RFI

RFI #: 175
Date: 7/27/2012
Job: EB-02 Keller Springs Lofts
Phone: 877-777-5115

Subject: Air handlers and CFM columns

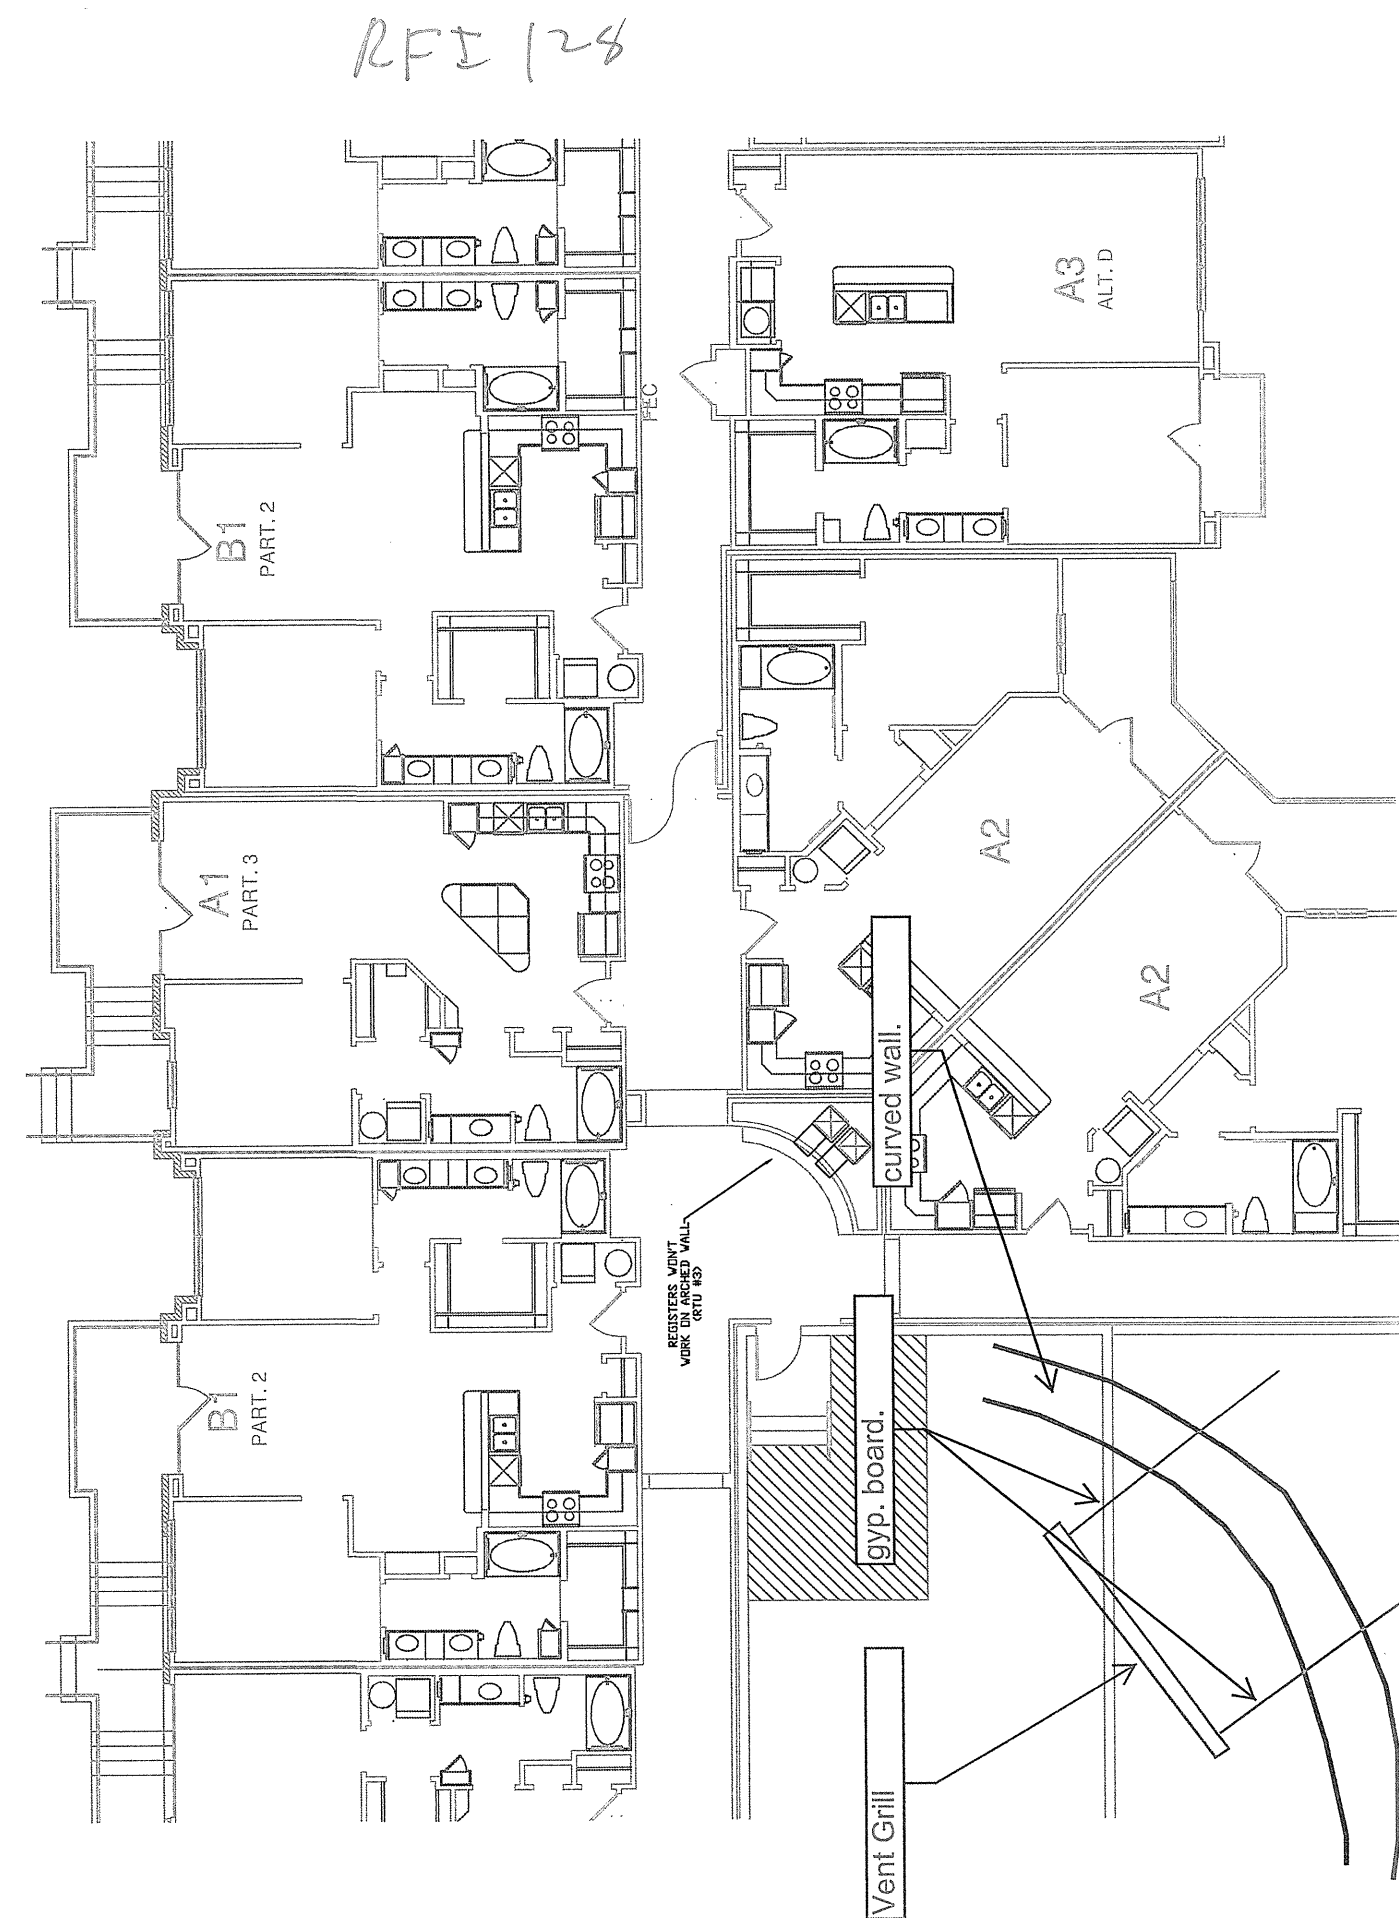
- The curved corridor wall at section C needs to be flat or have flat areas to mount the grilles.
- The corridor wall at the shaft works well on floors 2-4 but changes on the first floor and creates a problem. Suggest using the upper floor configuration on the first floor.

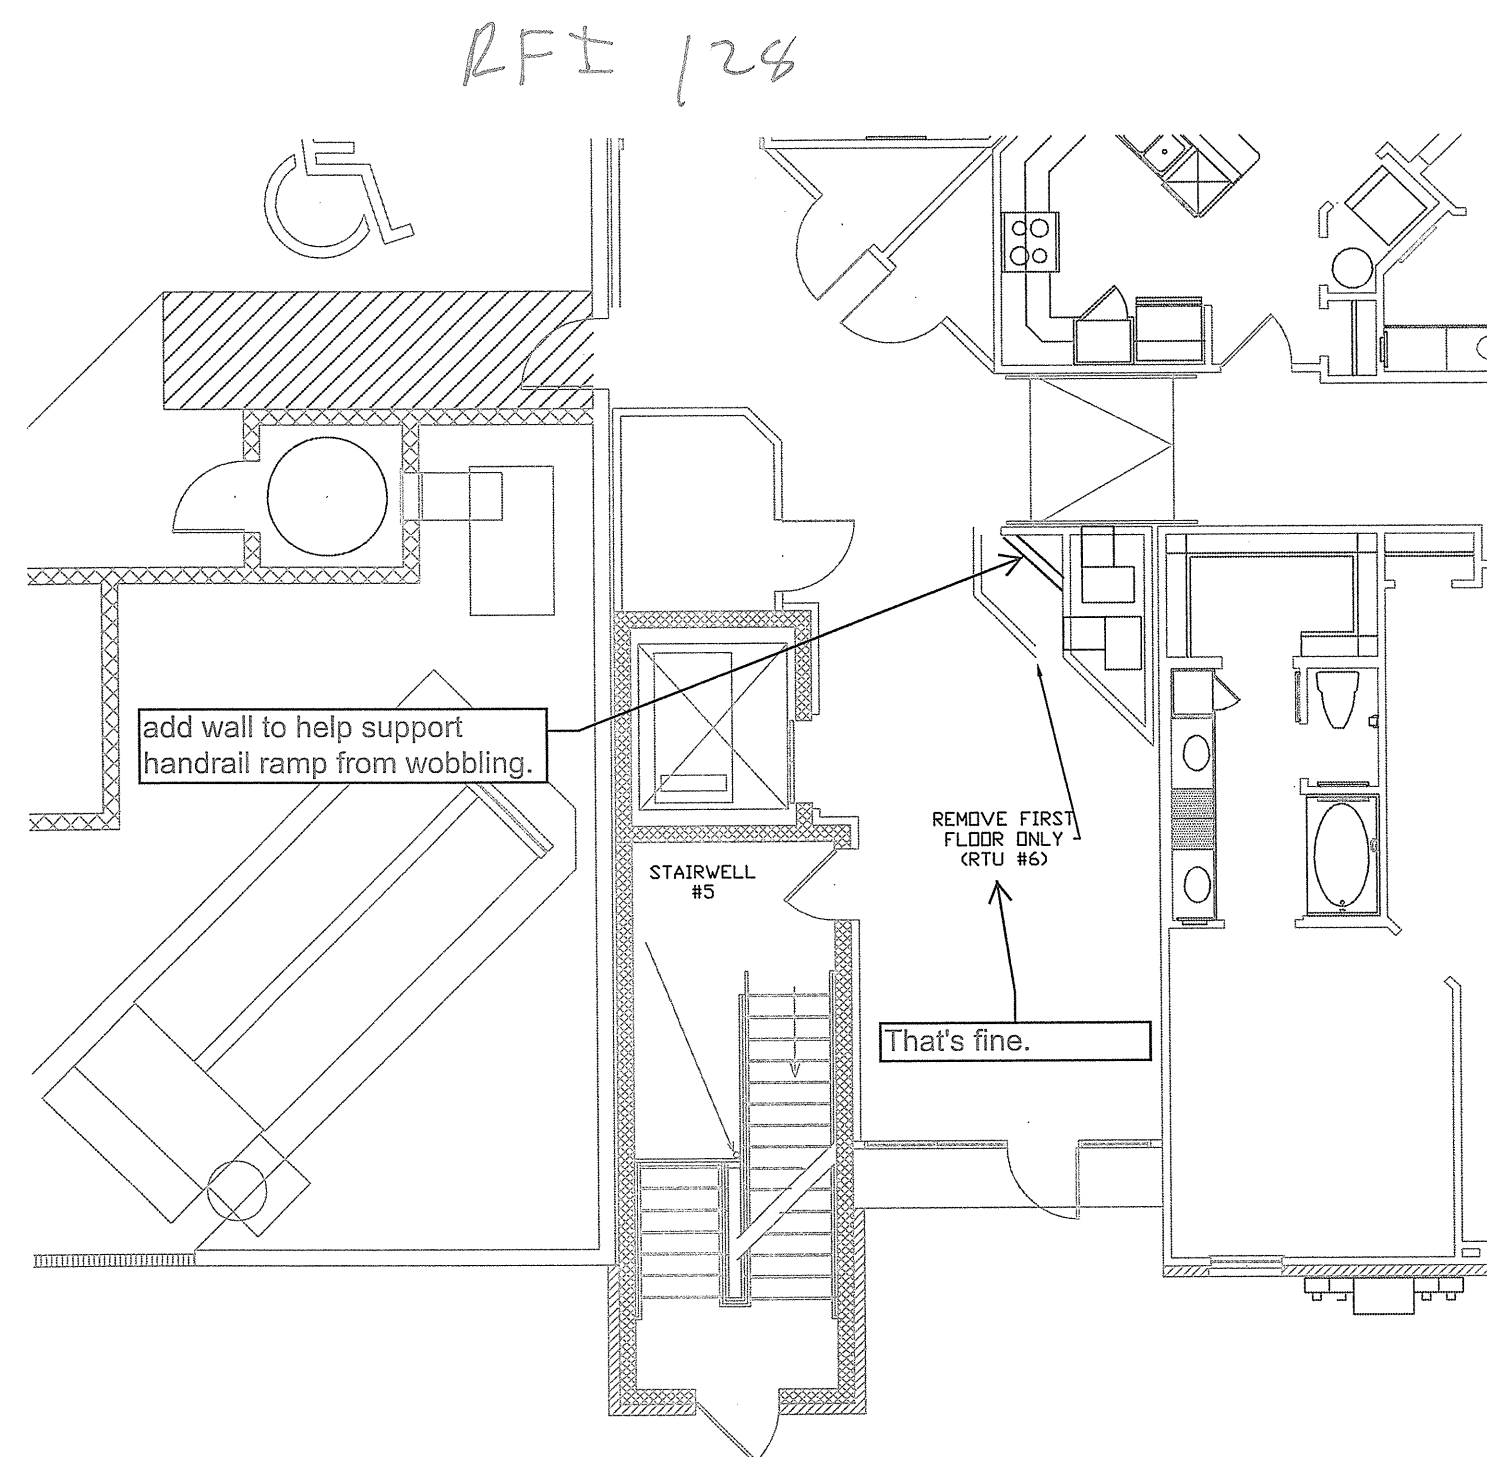
Request: Date Required: 6/7/2012
 The supply and return air grills will not work on the curved walls on each floor as shown on A3.1C, A3.2C, A3.3C and A3.4C. A portion of the wall will need to be straight for the grills.

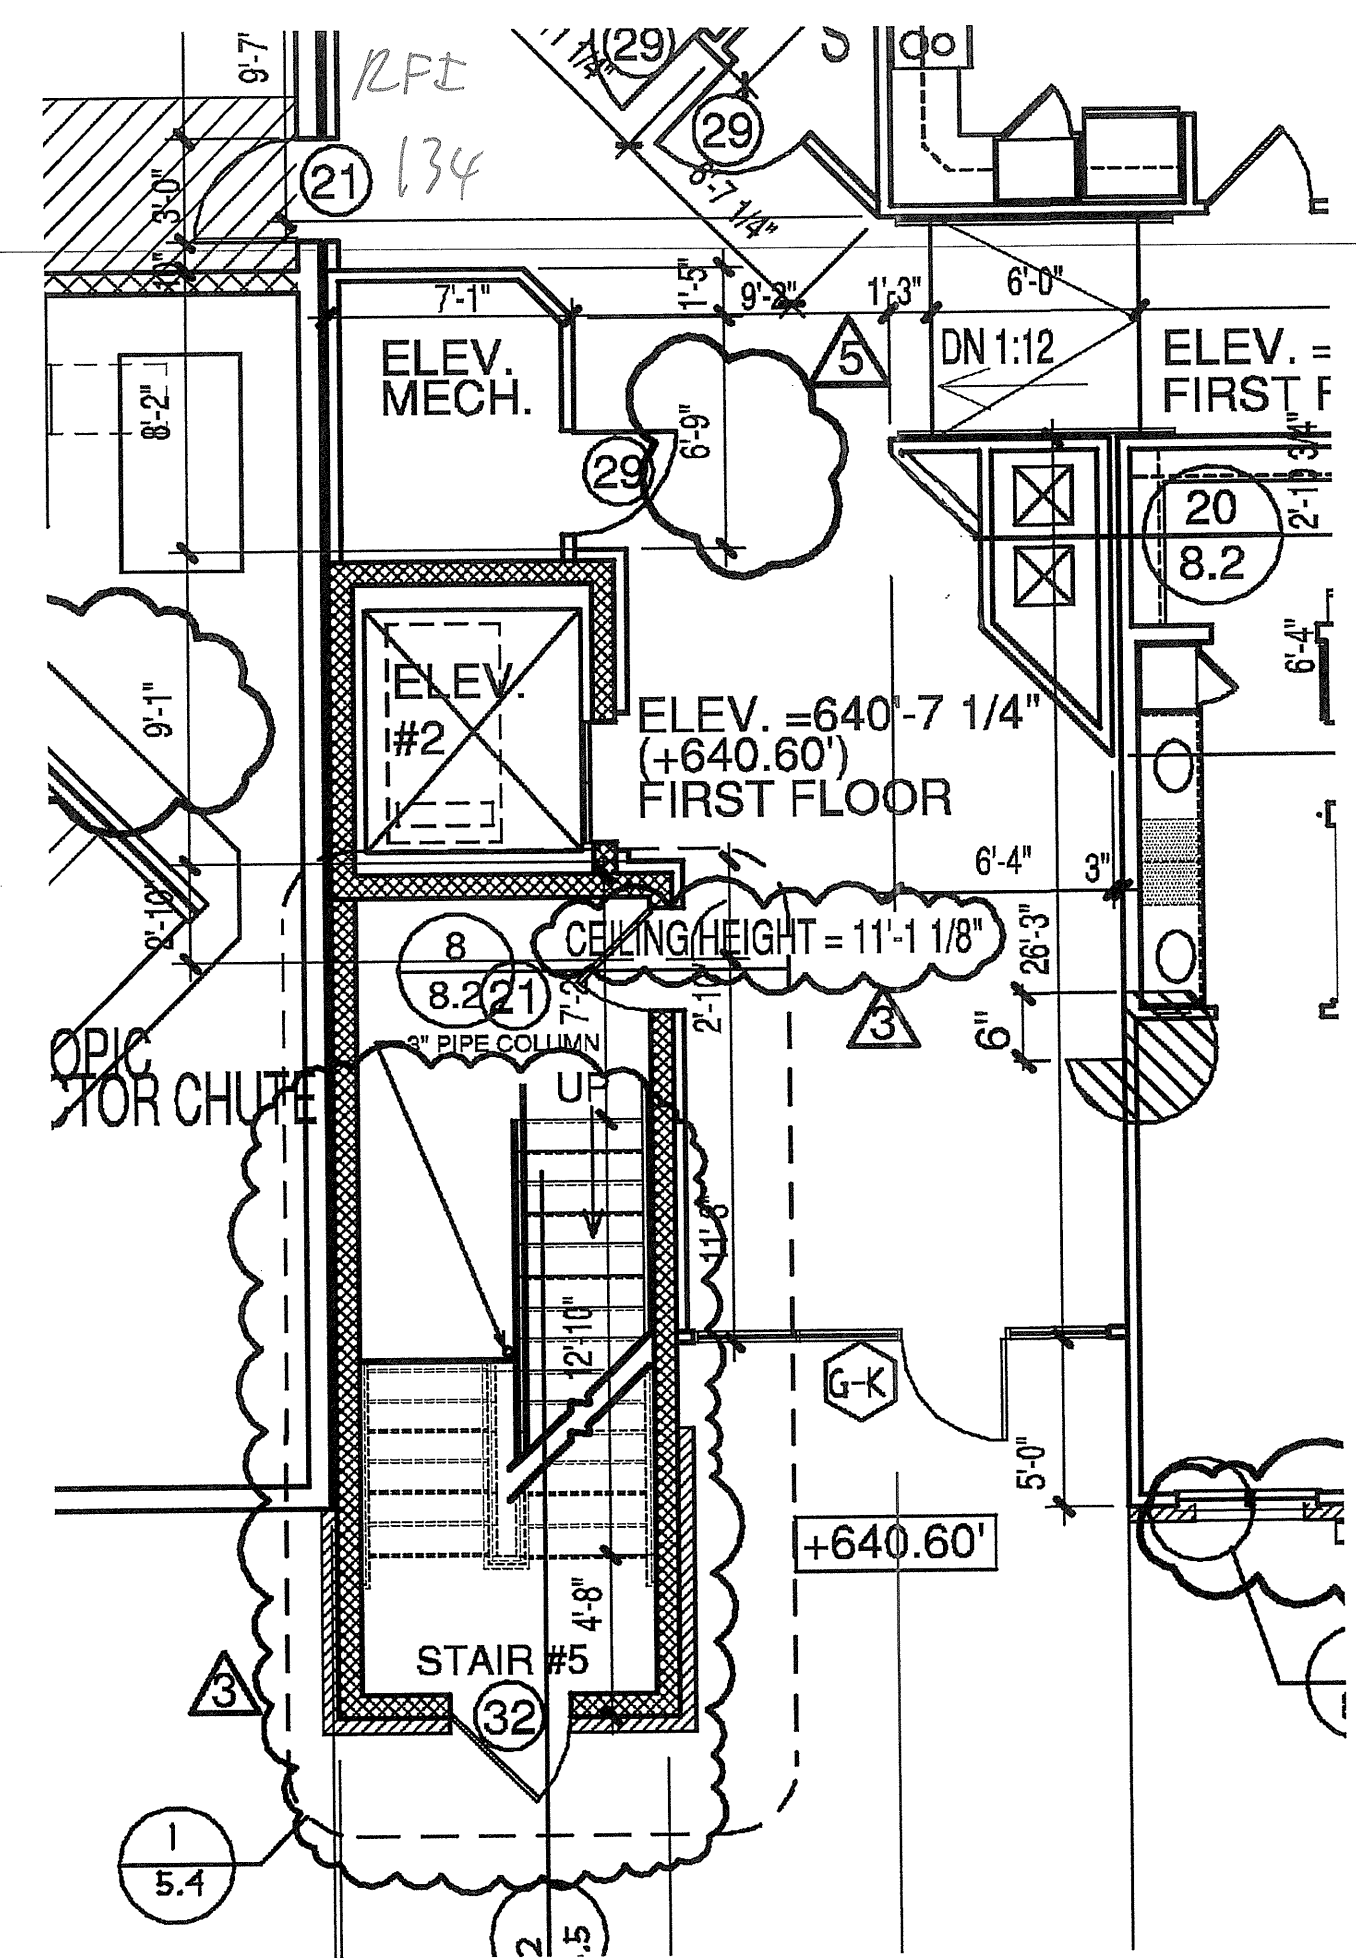
Request: Date Required: 6/7/2012
 Due to the ramp at the mechanical shaft (near elevator #2), there is an added wall on the first floor that is not shown on the other floors. This additional wall will cause issues with the grill located in that area. Detail 7/M4.2 shows the walls as they will be on floors 2, 3 and 4. Can the additional wall be modified to give the HVAC sub room for his grill? Please see attached sketch.

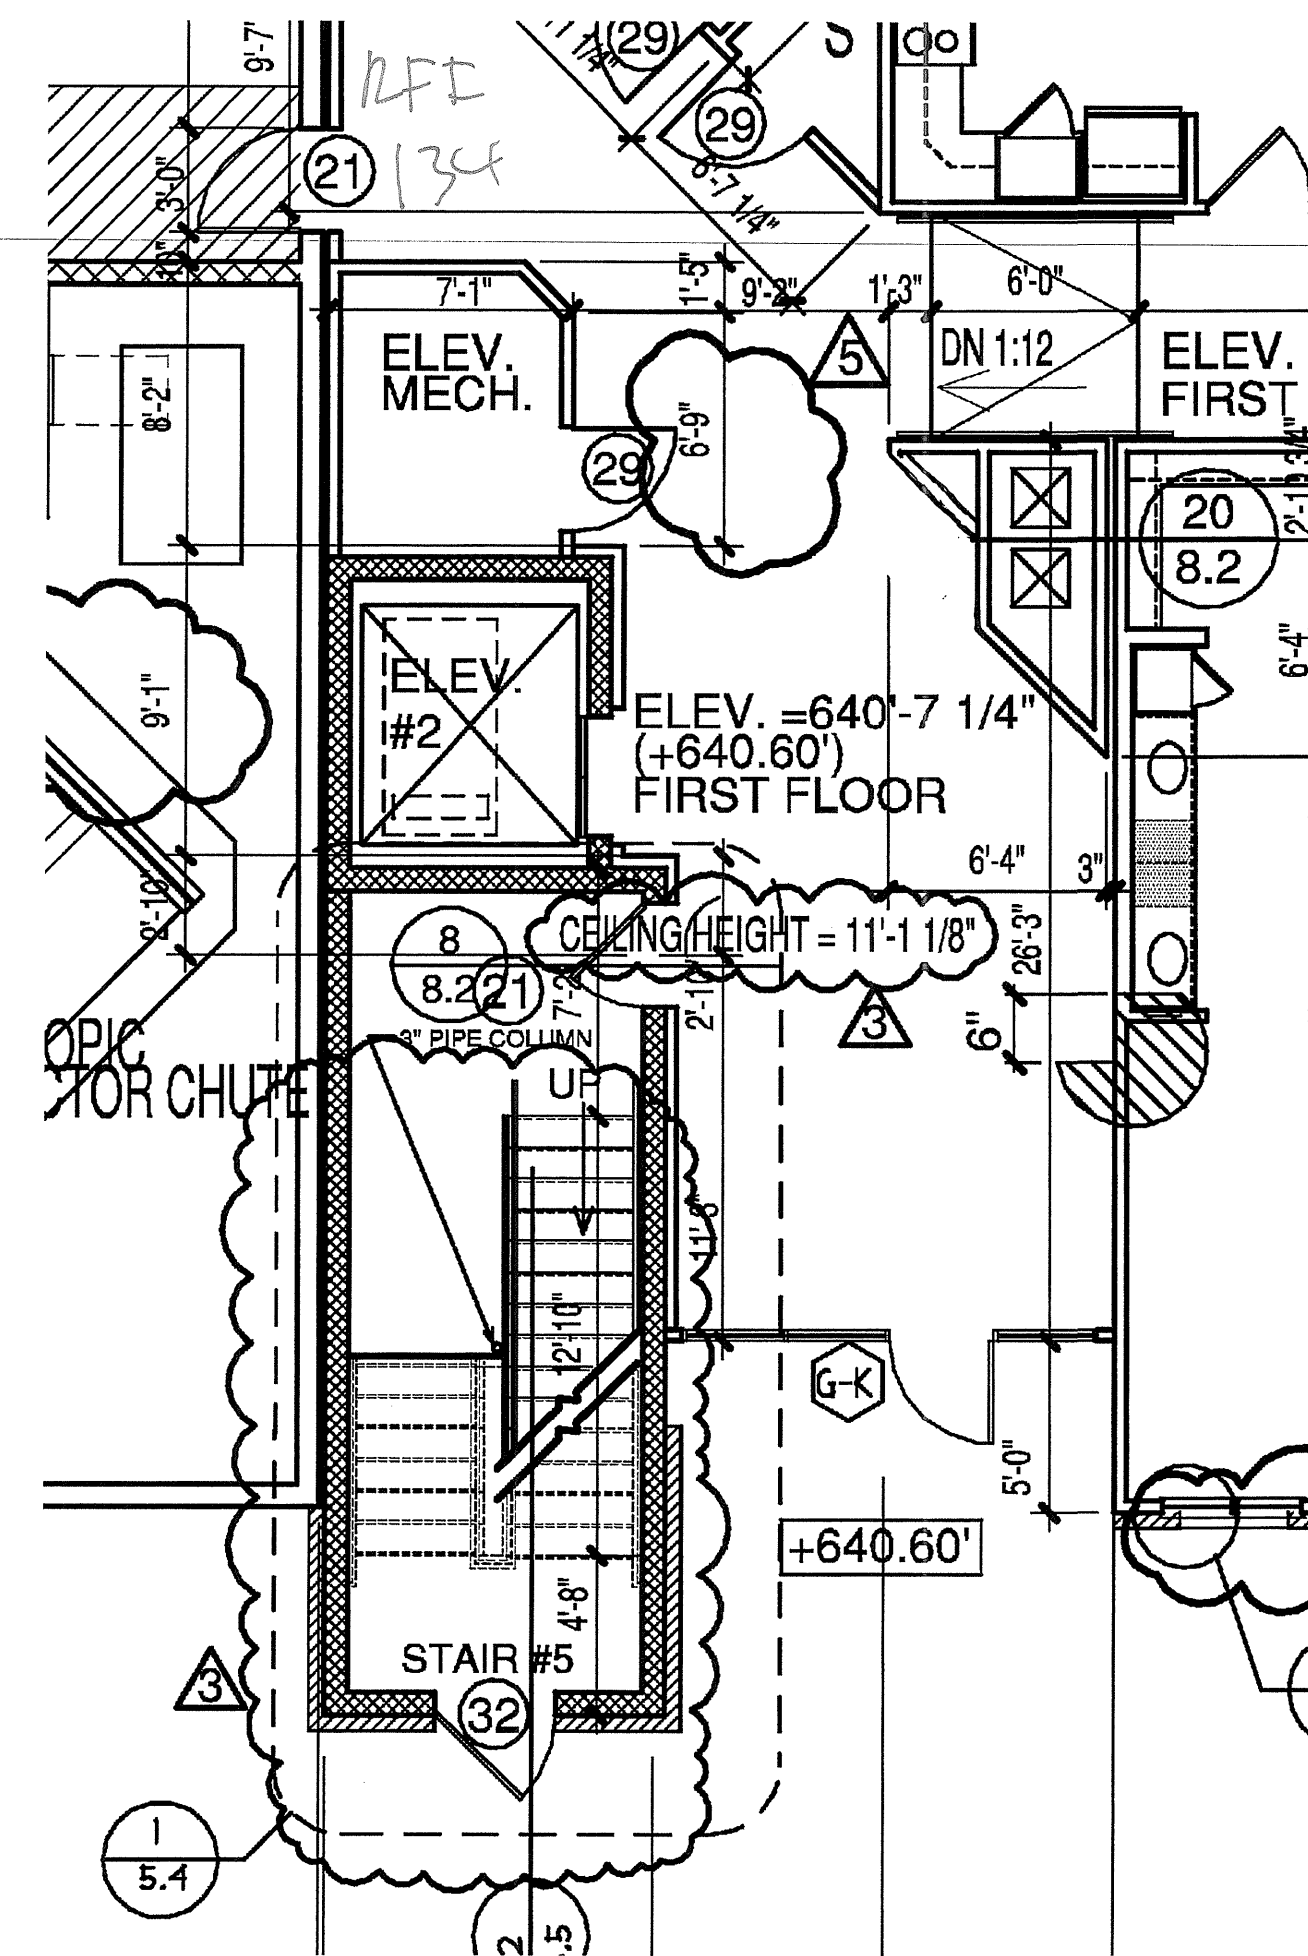
Due to the ramp at the mechanical shaft (near elevator #2), there is an added wall on the first floor that is not shown on the other floors. This additional wall will cause issues with the grill located in that area. Detail 7M4.2 shows the walls as they will be on floors 2, 3 and 4. Can the additional wall be modified to give the HVAC sub room for his grill? Please see attached sketch.
